Re: Waste License Application Ref. No. W0231-01, Fingal Landfill

Thank you for your letter of November 30th, 2006, with further queries requesting the GSI's comments. My responses are below.

Figure 6. Dinantian successions in north Co. Dublin (after Nolan 1989, Somerville *et al.* 1992)

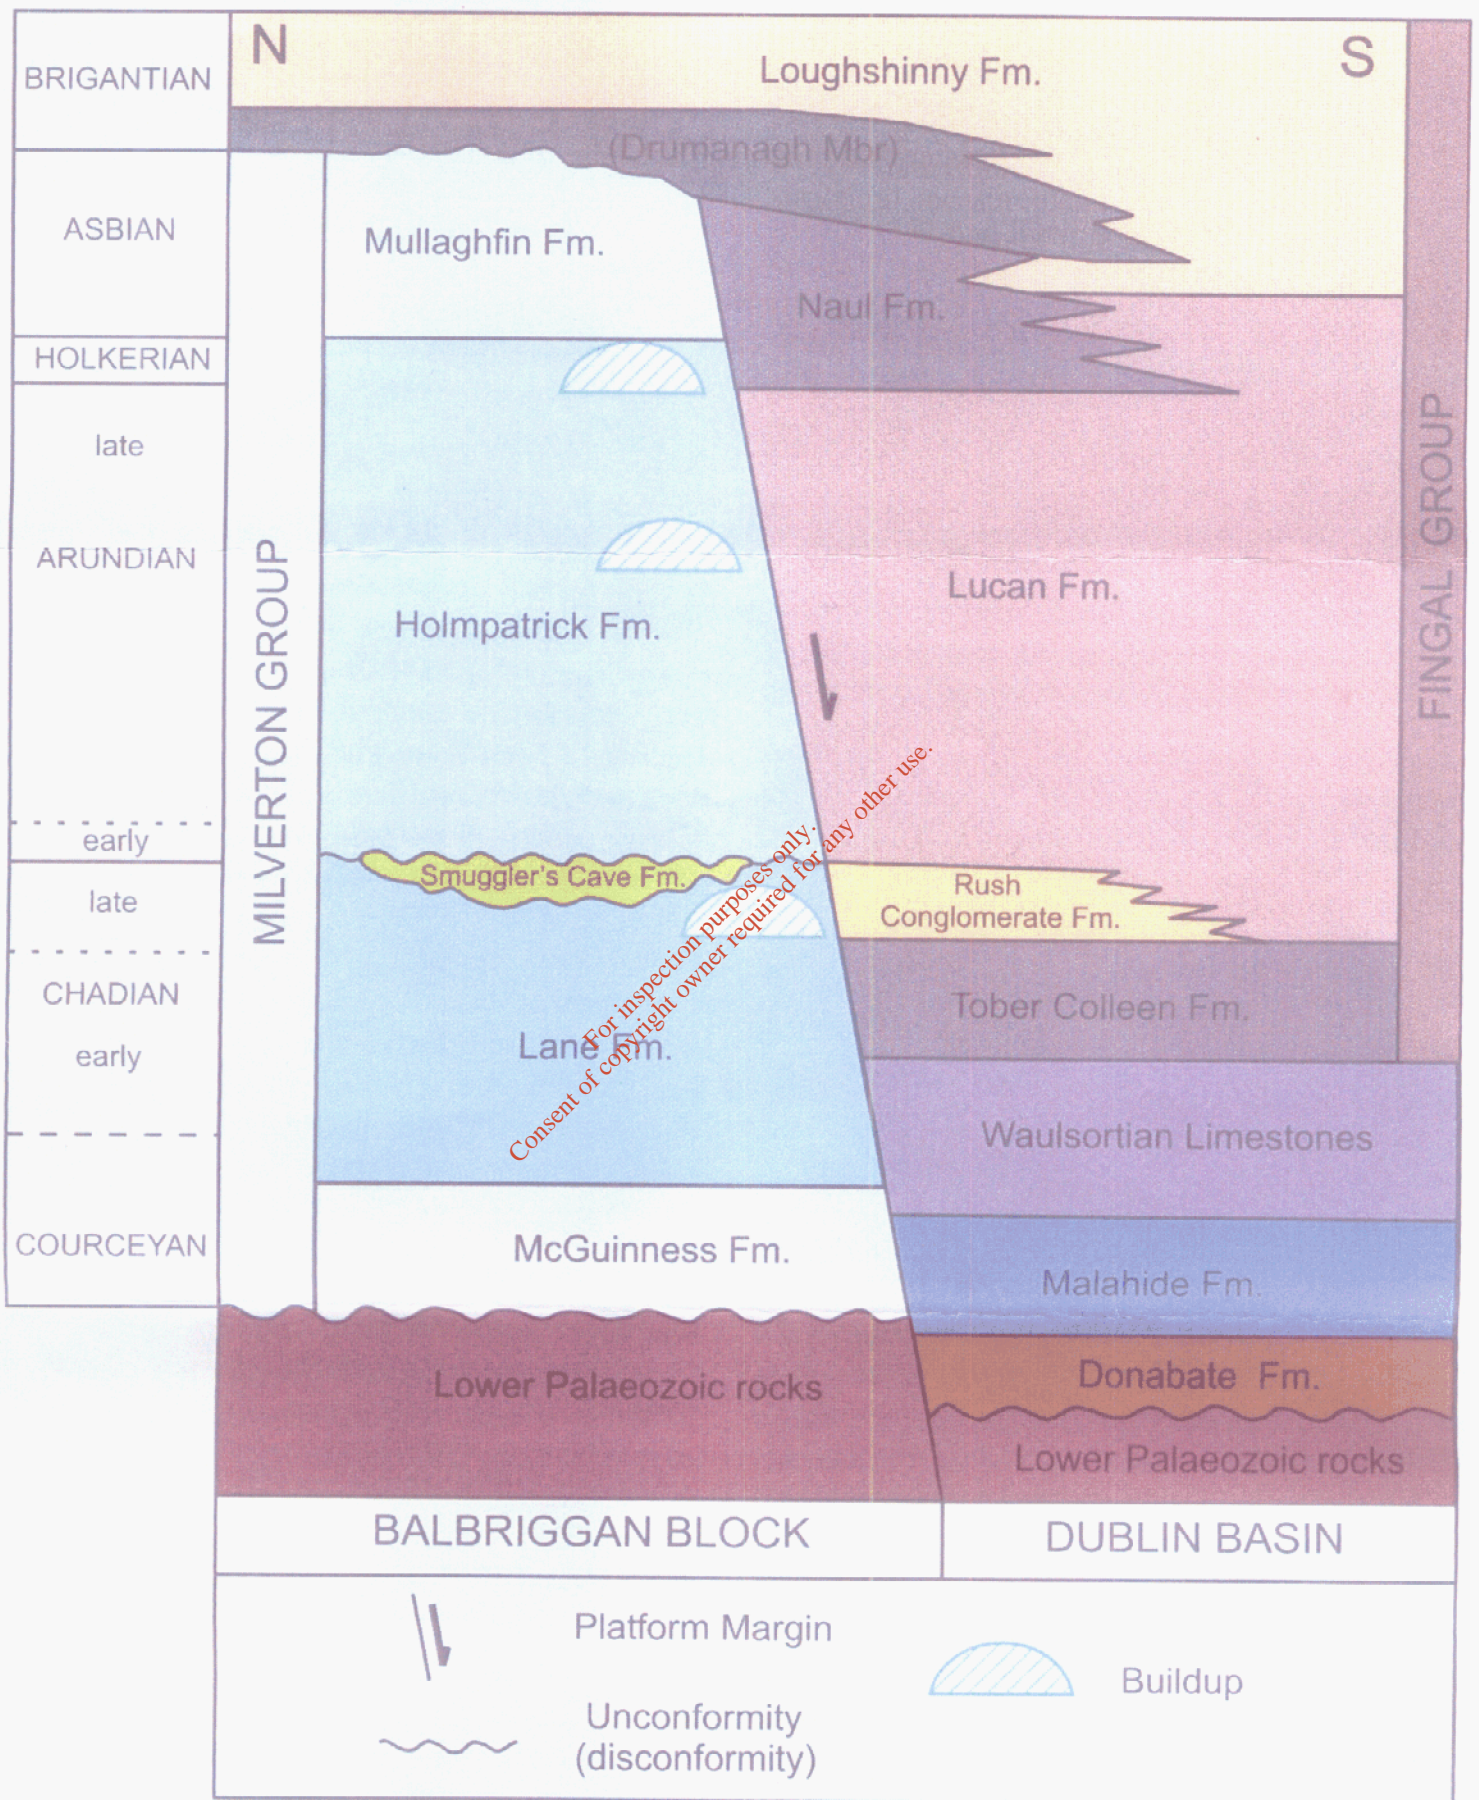
(i) The cross-section in the GSI's report (Bog of the Ring Source Protection Zone) was constructed using established methods of (a) choosing a section line orientation; (b) marking-off Formation/Member boundaries from the bedrock map along the section; (c) computing apparent bedding dips as a function of the section/bedding dip orientation and vertical:horizontal exaggeration; (d) extrapolating Formation/Member boundaries into the subsurface using basic geological principles, and published thickness data. The section in the GSI's report honours the published map (Sheet 13) boundaries. However, as pointed out by Kevin Cullen, it is notable that, in the 2D section construction, the Loughshinny Formation as drawn does thin significantly from north to south. I have spoken to the Bedrock Section within the GSI and they note that the limestones were deposited along a synsedimentary fault and therefore do change in thickness. They also display a change from shelf-type pure bedded limestone immediately adjacent to the fault to more basinal-type, impure limestones further south, away from the North Dublin Fault zone. Please see the attached diagram, abstracted from the GSI report accompanying Bedrock Sheet 13 (Mc Connell, Philcox, Geraghty, 2001). Discerning the precise nature of the bedrock geometry is complicated by the thick blanket of glacial tills covering the bedrock, and the mapped boundaries may need revision in the light of more information. However, the cross-section, as drawn in the report (Bog of the Ring Source Protection Zone), could be improved by accounting for the change from shelf- to basinal-type limestones from north to south. However, as the impure limestones (Loughshinny, Naul and Lucan Formations) behave in a hydrogeologically similar manner, this distinction is not critical in the assessment of groundwater flow in the area to the south of the Bog of the Ring. What is more important is the depth to which significant fracturing and fissuring occurs.
